Contract #: 04-0120F4Cty: SF/ALA Rte: 80 PM: 13.2/13.9File #: 69.25B**QUALITY ASSURANCE -- NON-CONFORMANCE REPORT****Location:** Changxing Island, Shanghai P.R. China**Report No:** NCR-000951**Prime Contractor:** American Bridge/Fluor Enterprises, a JV**Date:** 18-Dec-2010**Submitting Contractor:** Zhenhua Port Machinery Company, Ltd (ZPMC), Changxing Island**NCR #:** ZPMC-0910**Type of problem:**

Reference Description: One Longitudinal Indication found in Tower Suspender Bracket**Description of Non-Conformance:**

Job Name: SAS Superstructure

Subject: NCR No. ZPMC-0910

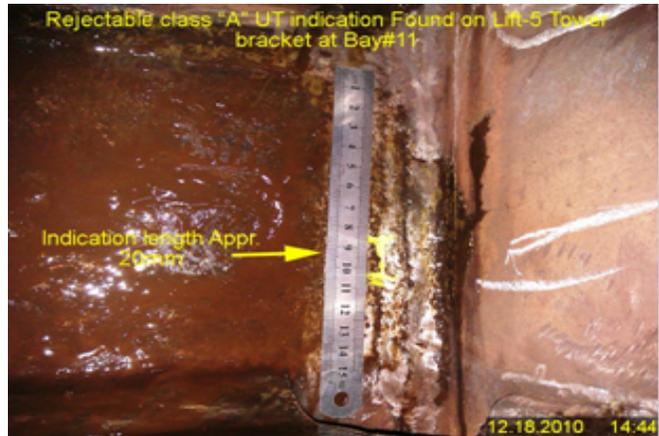
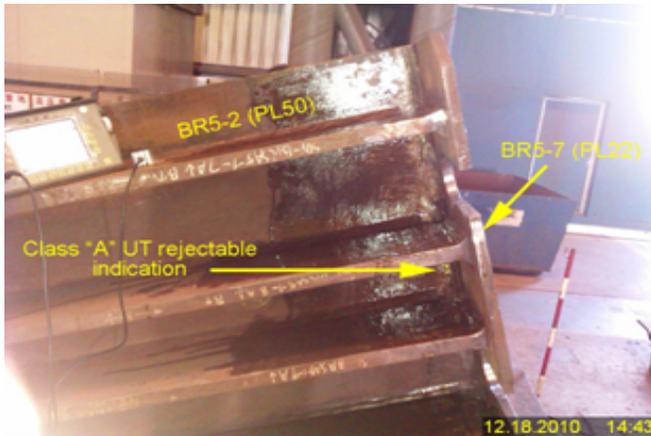
During the Quality Assurance Ultrasonic Testing (UT) review of welds located on Tower Lift-5 Bracket at Bay#11, this Quality Assurance Inspector (QA) discovered the following issues:

- One longitudinal linear Class "A" rejectable indication measuring approximately 20mm in length.
- The indication dbS rating is a +3.
- Material thickness is 50mm.
- The depth of the indication is approximately 28mm.
- The weld is identified as SD1-BRSA5-1-19.
- The weld is Complete Joint Penetration (CJP) "T" joint joining Web BR5-2(PL50) to flange BR5-7(PL22).
- The indication is clearly marked on or near the weld.
- The Y distance for this indication is 570 mm from edge of the bracket.
- The tower bracket is located at Bay#11.

The Notice of Witness Inspection (NWIT) No. is 07818. The indication is located within an area previously tested and accepted by ZPMC Quality Control (QC) personnel. As per the contract documents, ZPMC's QC personnel are required to perform 100% UT inspection of this weld.

AWS D1.5-02 Section 6; Table 6.3 specifies a class "A" indication as having a rating of 4dbs and under for material thicknesses 38mm through 60mm.

Propose a resolution for this non-conformance and provide documentation that the deficiency has been brought into compliance with the contract requirements. Propose a resolution that addresses the apparent failure of Quality Control to identify the indication. Additionally, provide documentation of the steps taken by the Quality Control Manager to prevent future occurrences.

Reference Description: One Longitudinal Indication found in Tower Suspender Bracket

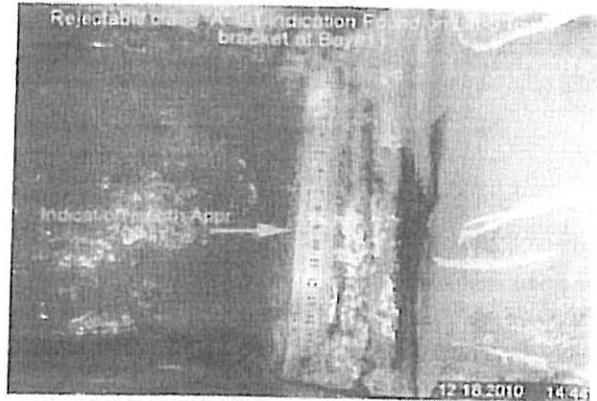
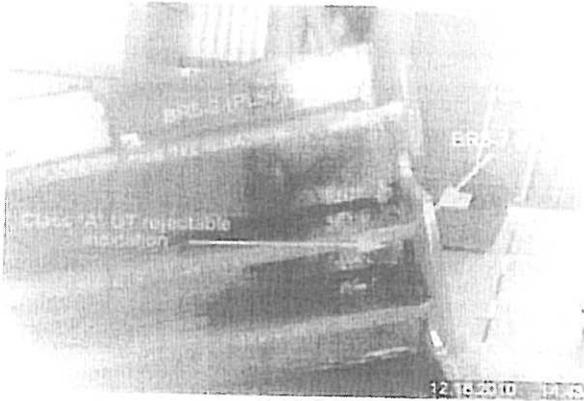
During the Quality Assurance Ultrasonic Testing (UT) review of welds located on Tower Lift-5 Bracket at Bay#11, this Quality Assurance Inspector (QA) discovered the following issues:

- One longitudinal linear Class "A" rejectable indication measuring approximately 20mm in length.
- The indication dbS rating is a +3.
- Material thickness is 50mm.
- The depth of the indication is approximately 28mm.
- The weld is identified as SD1-BRSA5-1-19.
- The weld is Complete Joint Penetration (CJP) "T" joint joining Web BR5-2(PL50) to flange BR5-7(PL22).
- The indication is clearly marked on or near the weld.
- The Y distance for this indication is 570 mm from edge of the bracket.
- The tower bracket is located at Bay#11.

The Notice of Witness Inspection (NWIT) No. is 07818. The indication is located within an area previously tested and accepted by ZPMC Quality Control (QC) personnel. As per the contract documents, ZPMC's QC personnel are required to perform 100% UT inspection of this weld.

AWS D1.5-02 Section 6; Table 6.3 specifies a class "A" indication as having a rating of 4dbs and under for material thicknesses 38mm through 60mm.

WELD NUMBER: SD1-BRSA5-1-19A/B

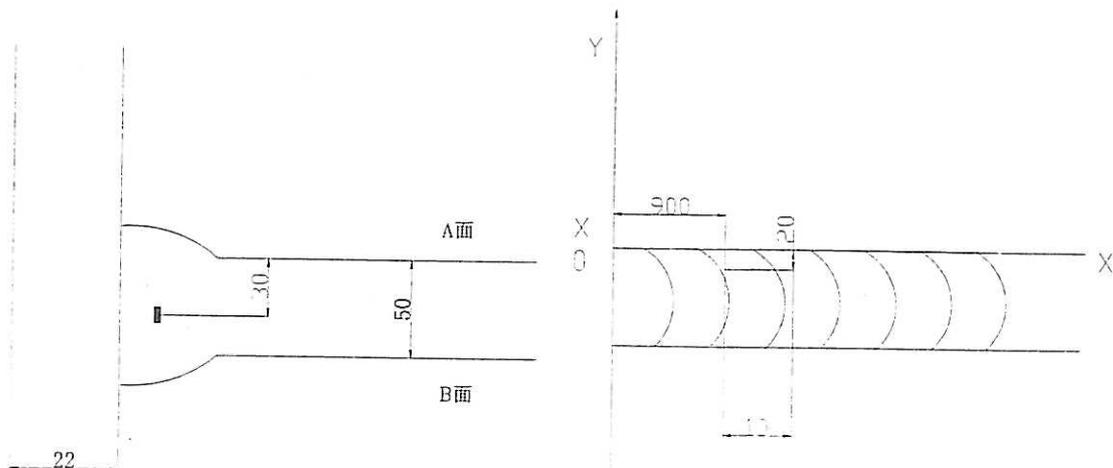
Weld No. 焊缝编号为：SD1-BRSA5-1-19A/B

1. Did not clear the weld pass completely in time.

1. Prepare the joint according to the approved WPS.
2. Grind or gouge the repair area to a smooth finish according to the approved repair WPS.
3. Remove all defects by grinding to ensure all defects are completely removed if defects still exist.
4. Preheat and weld according to the approved WPS.
5. Grind the weld flush after welding.
6. Perform NDT of the repair area.
